Project	IEEE 802.16 Broadband Wireless Access Working Group < http://ieee802.org/16 >	
Title	Clarification on STC Encoding for MIMO OFDMA	
Date Submitted	2004-11-18	
Source(s)	Wonil Roh, JeongTae Oh, Chan-Byoung Chae, Kyunbyoung Ko, Hongsil Jeong, Sung-Ryul Yun, Seungjoo Maeng, Jaeho Jeon, Jaeyeol Kim, Soonyoung Yoon	wonil.roh@samsung.com Voice: +82-31-279-3868
	Samsung Electronics Co., Ltd. Young-Ho Jung, Seung Hoon Nam , Jaehak Chung, Yungsoo Kim, Sung-Jin Kim, Hojin Kim Samsung Advanced Institute of Technology	
Re:		
Abstract	Clarification on STC Encoding for MIMO OFDMA	
Purpose	Adoption of proposed changes into P802.16e Crossed-out indicates deleted text , <u>underlined blue indicates new text change to the Standard</u>	
Notice	This document has been prepared to assist IEEE 802.16. It is offered as a basis for discussion and is not binding on the contributing individual(s) or organization(s). The material in this document is subject to change in form and content after further study. The contributor(s) reserve(s) the right to add, amend or withdraw material contained herein.

Clarification on STC Encoding for MIMO OFDMA

Figure 251a Illustration of STC for optional zones in DL (Matrix A for 2,3,4 Tx and Matrix B for 3,4 Tx)

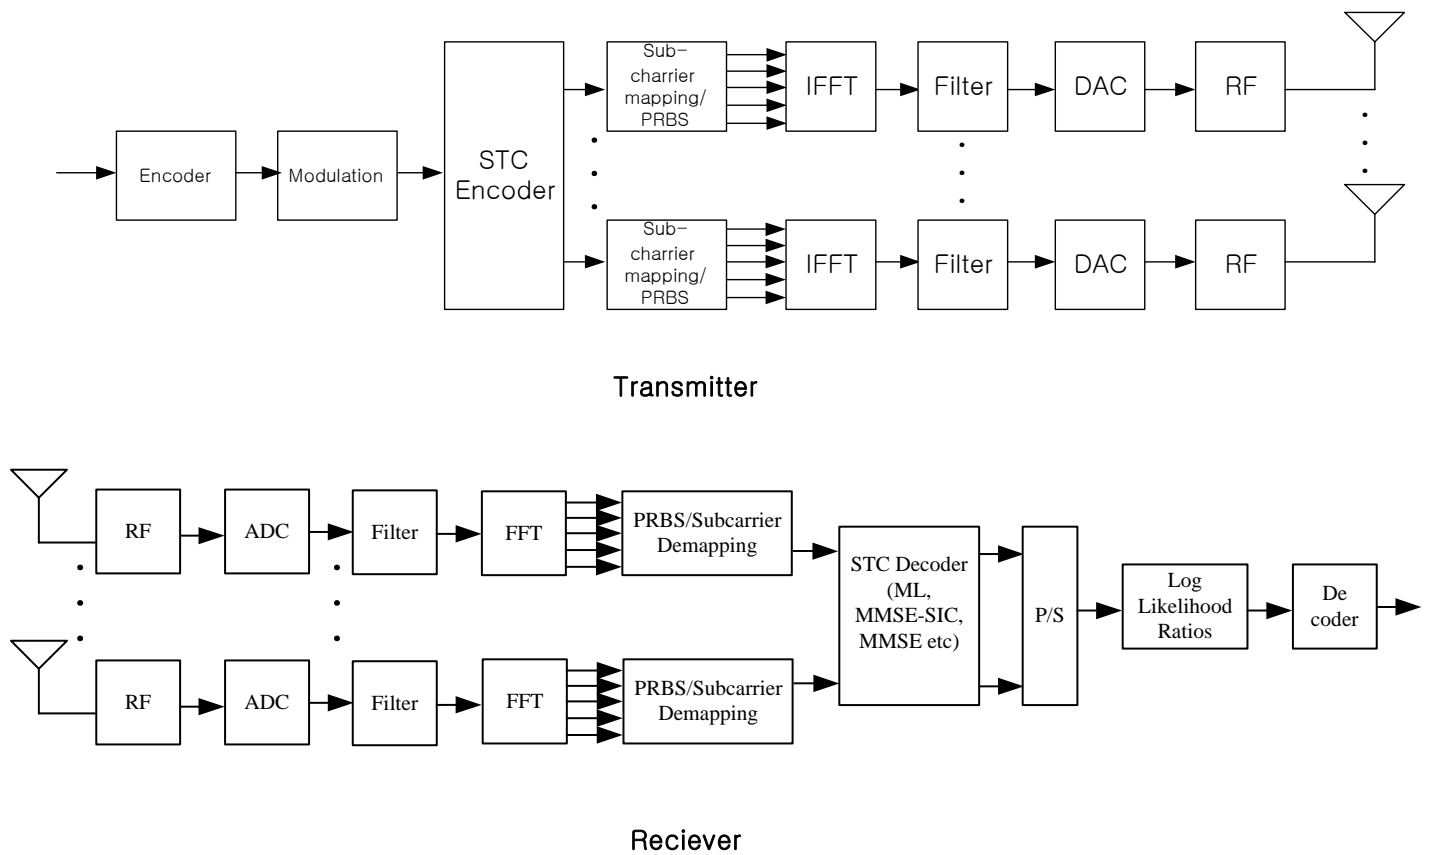
Two optional zones for the downlink, the optional FUSC and the optional AMC zones, are described in 8.4.6.1.2.3 and 8.4.6.3 [2], respectively. STC may be used to improve system performance for these zones and an example of transmit diversity (TD) with ~~2~~multiple tx and ~~4~~multiple rx is shown in Figure ~~251a~~. ~~Subcarrier mapping block in the figure denotes data truncation, if needed, pilot insertion and IFFT input packing.~~

[Replace Figure 232 in page 236 of [1] with the following]

In this Figure 251a the STC encoder operates on input symbols sequentially and distributes the antenna specific symbols to each antenna path. The block of subcarrier mapping and PRBS function denotes data truncation or puncturing, if needed, pilot insertion, IFFT input packing and each subcarrier multiplied by the factor $2*(1/2-w_k)$ according to the subcarrier index k in 8.4.9.4.1. The data truncation for CTC or the puncturing for CC encoder shall be required for 3 Tx and 4 Tx BS.

This Figure 251a also represents the usage of matrix B with vertical encoding for 3 or 4 Tx BS.

Figure 251b – Example Embodiment of Matrix B with Horizontal Encoding for 3 or 4 Tx BS for optional zones in DL

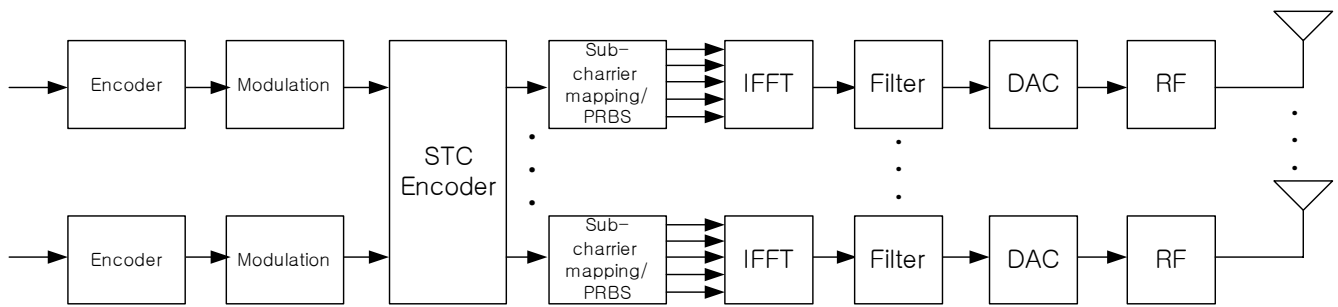
For the usage of matrix B with horizontal encoding for 3 or 4 Tx BS, an exemplary figure is shown in Figure 251b.

Figure 251c - Illustration of Matrix C with Vertical Encoding for 2,3,4 Tx BS for optional zones in DL

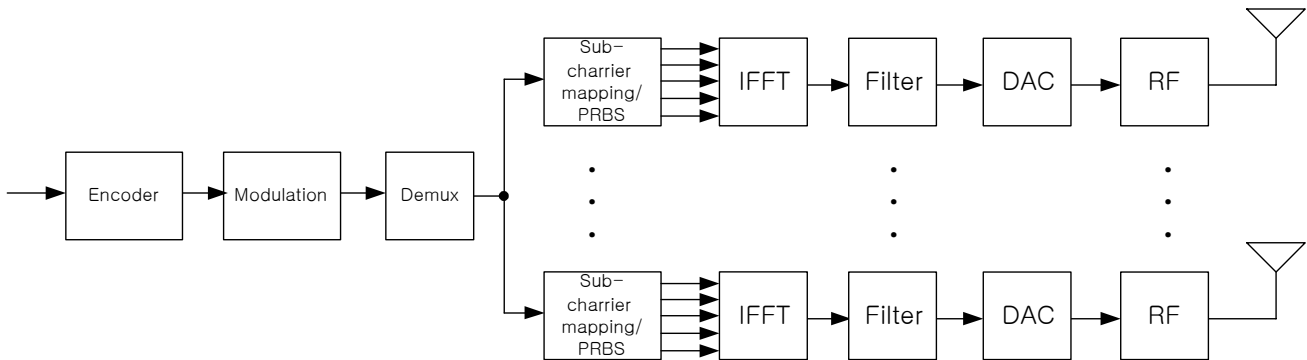
[Figure 251c illustrates the usage of matrix C with vertical encoding. The modulated symbols are distributed sequentially from the top to the bottom output paths](#)

Figure 251d - Example Embodiment of Matrix C with Horizontal Encoding for 2,3,4 Tx BS for optional zones in DL

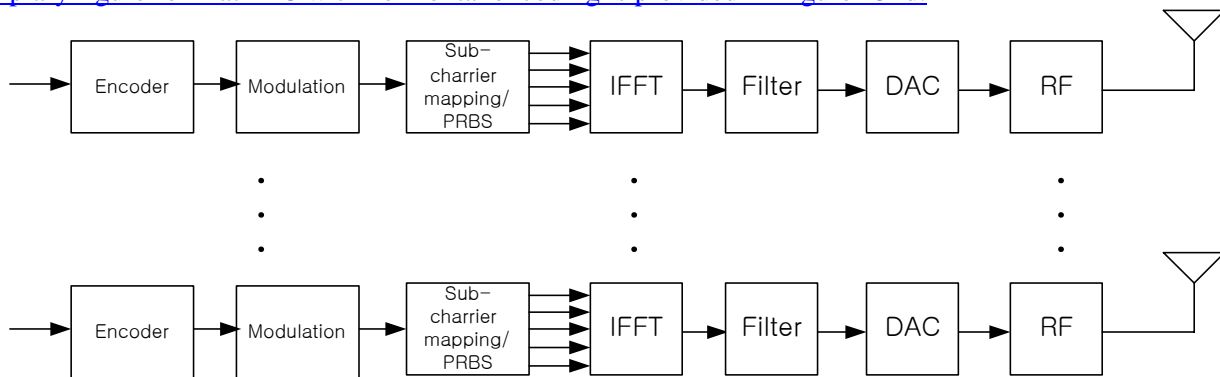
[An exemplary figure for matrix C with horizontal encoding is provided in Figure 251d.](#)

Figure bbb - Pilot allocation for 2-antenna BS for the optional FUSC and the optional AMC zones

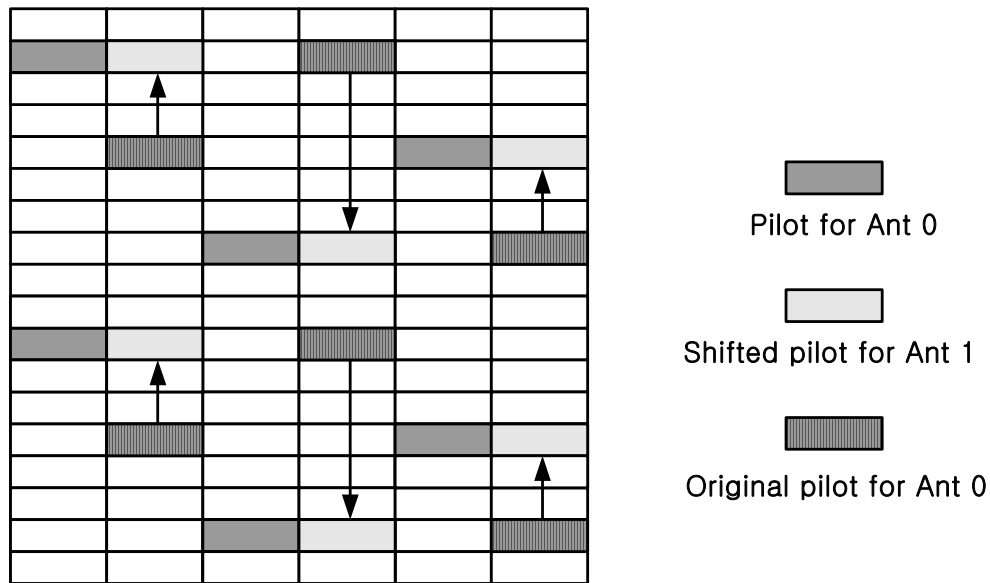
For 2-antenna BS, all pilots in the even symbols shall be allocated for antenna 0 whereas all pilots in the odd symbols shall be allocated for antenna 1. The positions of pilots in the odd symbols are further switched with those of data subcarriers whose locations coincide with pilots in the previous symbol. This is shown in Figure bbb.

Figure ccc - Pilot allocation for 4-antenna BS for the optional FUSC and the optional AMC zones

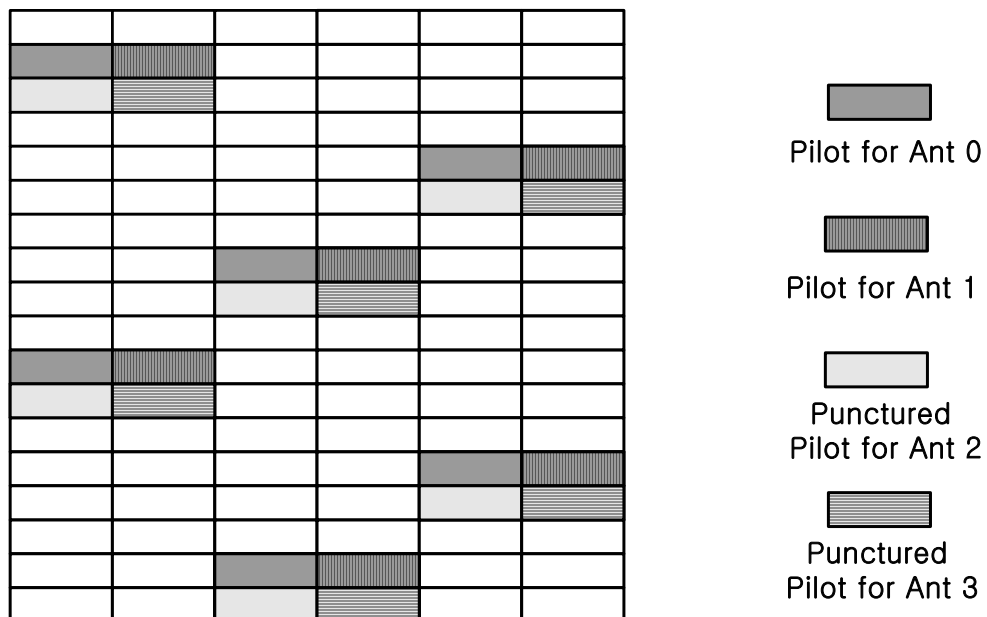
For 4-antenna BS, pilot pattern shall first be changed as in the 2-antenna BS case, and then the neighboring two subcarriers shall be further punctured for antenna 2 and 3 as shown in the figure ccc.
